Product Change Notification

Date Issued :	August 09, 2024	PCN Number :	515159
Reason for Change :	Change Supplier Manufacturing Process Change (Molex) Change to Product		
Description of Change :	This notification is to inform about expand metal supply sources, plating process, product design enhancement on spring contact, flash gold plating on back surface & additional pilot hole on carrier. No changes will be made to product as part of this change and only minor change on plating.		
Assessment of Change :	First Article Inspection		
Planned Implementation Date :	February 28, 2025		
Customer Sample Availability Date:	August 30, 2024		
Last date to request Samples by Customer :	August 30, 2024		
Please note if Samples are not requested as per Customer Samples Request date, it may take additional 4-6 weeks to arrange Samples.			
Traceability Code Markings / Date :	Date code

Product Appearance Change

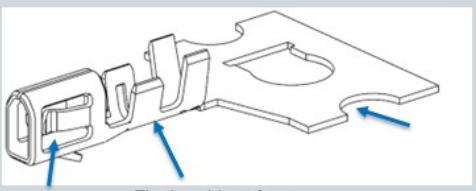
Before	After
<p>Crimp Terminal barrel plating change</p> <p>Before</p>  <p>Tin surface</p>	<ul style="list-style-type: none"> Product design enhancement on spring contact Flash gold plating on back surface. Additional pilot hole on carrier. <p>After</p>  <p>Contact spring design improvement</p> <p>Flash gold surface</p> <p>Add Pilot hole</p>
